10 August 2011

**NATIONAL ELECTRICITY AMENDMENT – PROJECT ERC0120
DEFINITION OF TEMPORARY OVER-VOLTAGE LIMITS - RULE 2011**

Figure 1

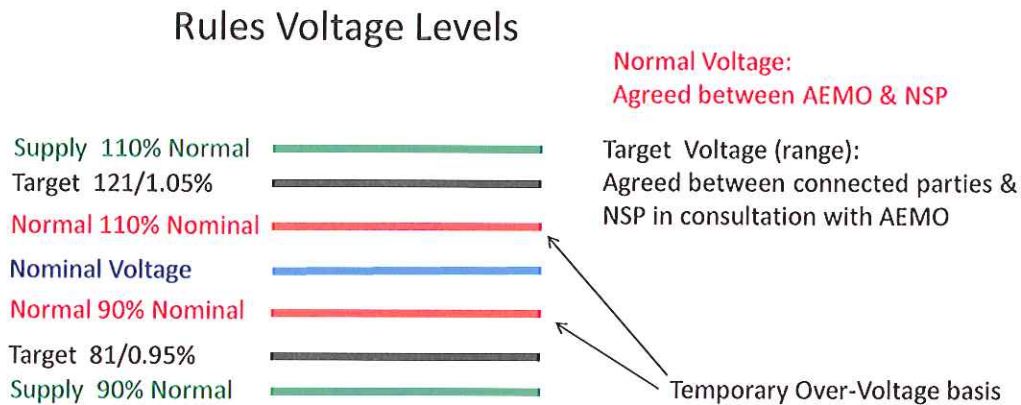
The provisions of the Rules in relation to voltages are currently quite complex and can be difficult to interpret. This complexity is illustrated below in Figure 1. It should be noted that it appears that the reference to S5.1a.4 in S5.3a.8 relating to target voltage should be S5.1.4. The introduction of another provision relating to voltage further increases this complexity. In addition, if increased ToVs are permitted above those based on *nominal* voltage there could be equipment design implications. This is expanded upon under Question 3.
